VILLAGE OF KEY BISCAYNE

RE: Site Plan Review: 101 Sunrise Drive

Section 3. **Site Plans Approved.** The site plan, attached as Exhibit "A," prepared by Gabriel Lopez Architect, P.A. entitled "R.E.A.C. 101 Sunrise," dated May 22, 2012, and consisting of 7 pages (the "Site Plan") is hereby approved.

RE: Site Plan Review: 101 Sunrise Drive

1 GROUND LEVEL PLANTING PLAN
AL

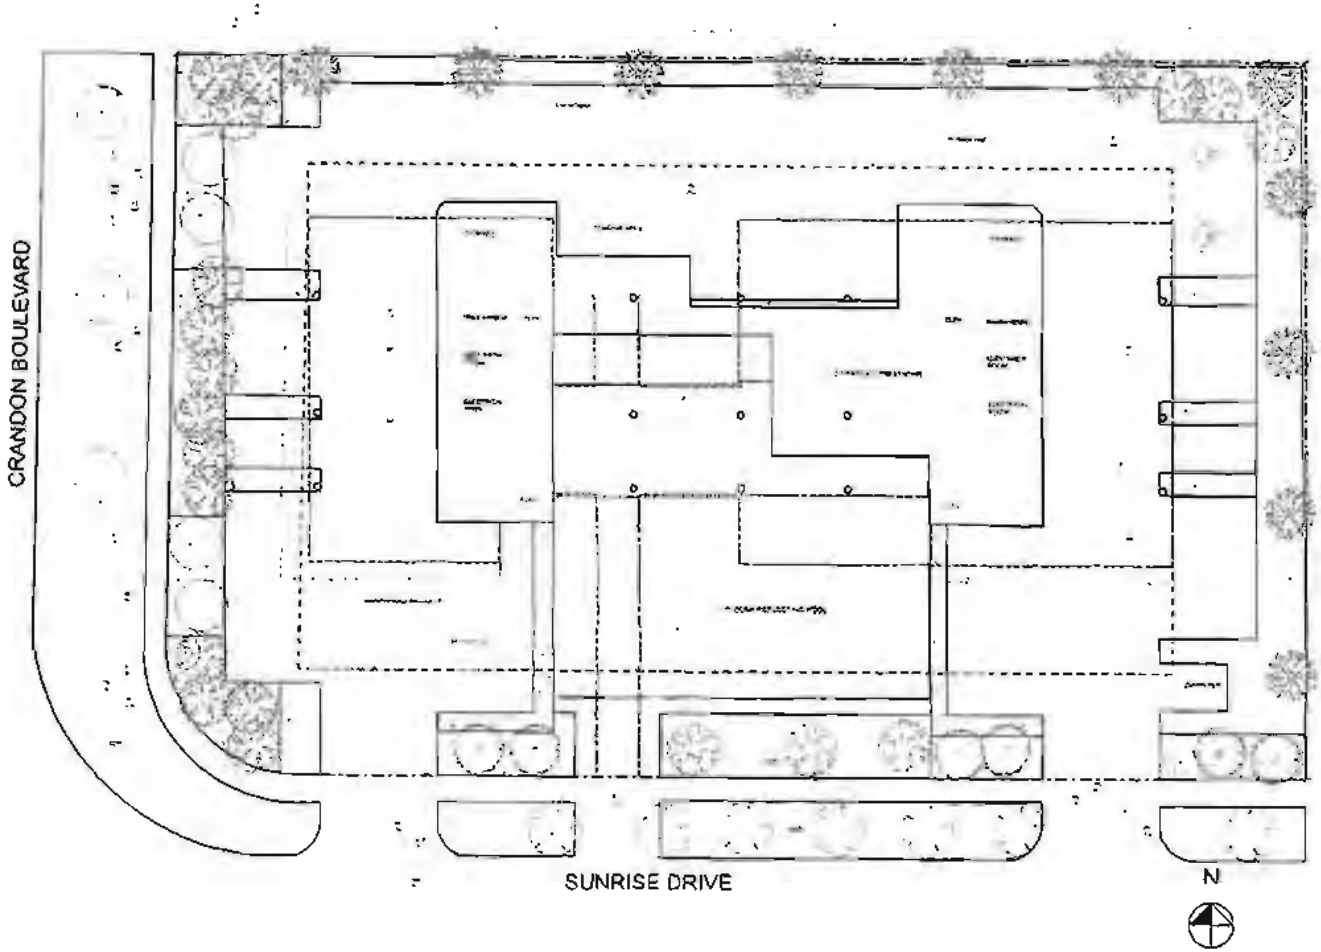
Analysis: The submission includes a Landscape Plan which is marked AL. The Landscape Plan includes a variety of trees including Buttonwoods (11), Native Pitch Apples (4), Green Malayan Coconuts (19), Glossy Privet (6) and Live Oaks (10). The existing site does not contain any trees that have significant value. The Landscape Plan also includes a variety of shrubs which will add interest and variety to the project. The type and location of the trees and shrubs compliment the project.

The site contains 14 mature coconut trees and a two (2) gumbo limbo tree. These trees should be retained and used on the property.

3. The Property contains 14 mature coconut trees and two (2) gumbo limbo trees. These trees shall be retained and used on the Property. The plans shall contain this note on the landscape plan that is submitted by the Applicant for a building permit.
